UNITED STATES PATENT AND TRADEMARK OFFICE

APPLICATION NO.	FILING DATE	FIRST NAMED INVENTOR	ATTORNEY DOCKET NO.	CONFIRMATION NO.
09/847,759	05/02/2001	Mark J. Hall	HANBEV.002RA	6043

Office Action Summary

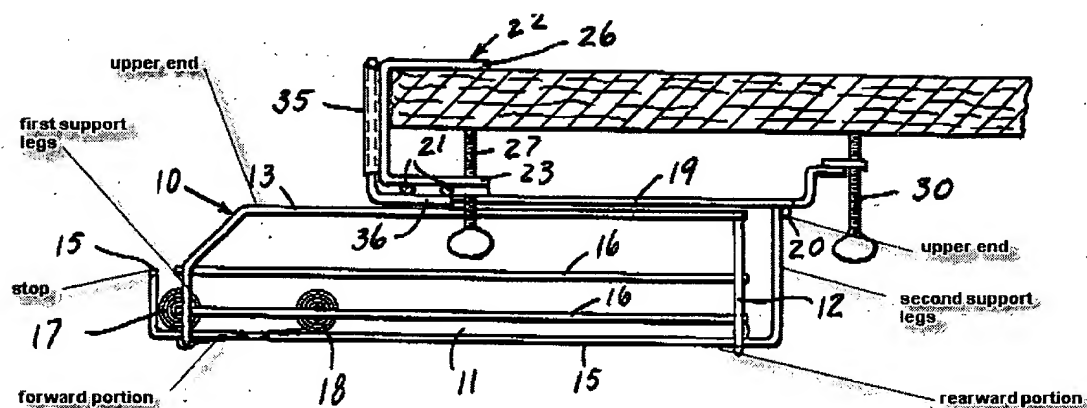
Claims 20, 22-24, 26, 28, 29, 30, 32, 35, 36, 39, 49-52 and 63-67 are rejected under 35 U.S.C. 103(a) as being unpatentable over Dickson in view of Lockwood. Dickson discloses a rack 10 comprising a support assembly 15 having a forward portion (labeled below) and a rearward portion (labeled below) and being configured to support a plurality of beverage containers; a first pair of support legs (labeled below) having lower ends connected to the forward portion; and a second pair of support legs (labeled below) having lower ends connected to the rearward portion, each of the first and second pairs of support legs having upper ends (labeled below) configured to hang the rack from a shelf disposed above the rack; a spacing defined between the upper ends of the second pair of support legs and the rearward portion of the support assembly sized so as to allow beverage containers to be inserted between a rear portion of the shelf and the rearward portion of the support assembly; a stop (labeled below) disposed at the forward portion of the support assembly, wherein the first and second pairs of support legs are sized, i.e., the second pair of support legs are longer than the first pair of support legs, such that the forward portion hangs lower than the rearward portion when the rack is hanging, by the upper ends of the first and second pairs of the support legs, from a horizontal shelf. It should be noted that the rack 10 of Dickson, although not shown, is capable of hanging with the front portion lower than the rear portion by

merely adjusting the threaded fastener 30 (see column 2, lines 42-46); threaded fasteners 27 connecting the upper ends of the first and second pairs of support legs to the shelf; wherein the support assembly is configured to support a plurality of parallel files of beverage containers extending between the rearward portion and the forward portion; wherein the support assembly comprises a wire frame configured to allow cylindrical beverage containers to roll along an upper surface thereof; a plurality of supports 21, 23 configured with sufficient strength to support additional shelving above the beverage containers supported on the first surface; the plurality of supports comprise at least two rod members; apertures (not numbered, but shown where the fasteners 27 penetrate the supports 23). Dickson is silent concerning a panel.

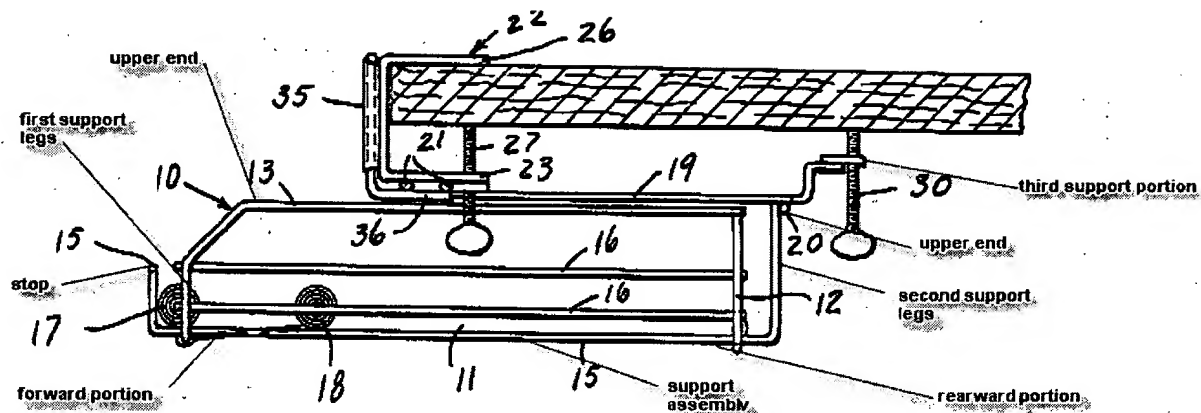
Claims 57-59 are rejected under 35 U.S.C. 103(a) as being unpatentable over Dickson in view of Lockwood. Dickson discloses a shelf 10 comprising: a support assembly (labeled below) having a forward portion (labeled below) and a rearward portion (labeled below), the support assembly defining a support surface configured to support a plurality of cylindrical beverage containers; a stop (labeled below) disposed at the forward portion of the support assembly; first and second support portions 22 disposed at the forward portion of the support assembly, the first and second support portions including upper ends, respectively, disposed above the plurality of cylindrical beverage containers supported on the support surface; at least first and second apertures (not numbered, but comprising the apertures through which the fasteners 27 extend) disposed adjacent the upper ends of the first and second support portions, respectively, the first and second apertures being configured to receive fasteners 27 for supporting the forward portion of the support assembly from a shelf 32 above the support assembly, the first and second apertures being spaced rearwardly from the stop; a third support portion (labeled below) disposed at the rearward portion of the support assembly, the third support portion including an upper end (not numbered, but

shown in figure 3); and at least a third aperture (not numbered, but comprising the aperture through which the fastener 30 extends) disposed adjacent the upper end of the third support portion, the third aperture being configured to receive a fastener 30 for supporting the rearward portion of the support assembly from a shelf above the support assembly; wherein the third aperture is spaced from a rearward-most portion of the rearward portion of the support assembly such that cylindrical beverage containers can be placed onto the rearward portion of the support assembly when the third aperture is connected to a shelf 32 disposed above the support assembly by fasteners. Dickson is silent concerning a panel configured to support a label and a fourth support portion.
